Motorola Mobility LLC.

Product Equality Declaration

The differences between EMEA SS and previous as below:

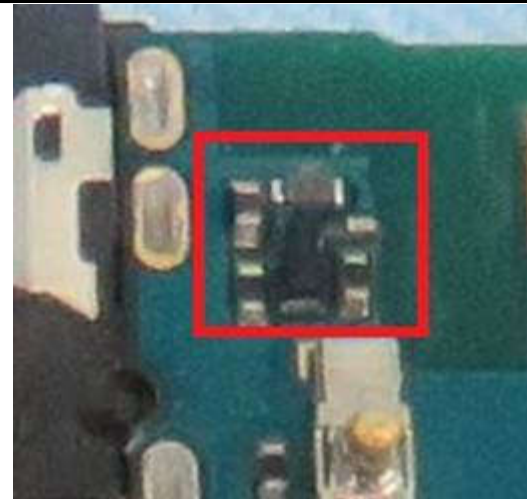
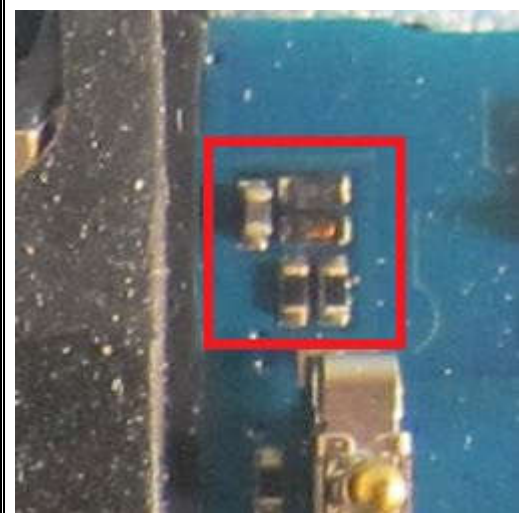
Previous 711913-01

Current 742708-01

Previous: Manual to remove SAR Sensor Chip and SAR Sensor shrapnel;
Current: Optimizing the BOM patch and removing the Sar sensor and its matching circuits.
These changes have no effect on RF.
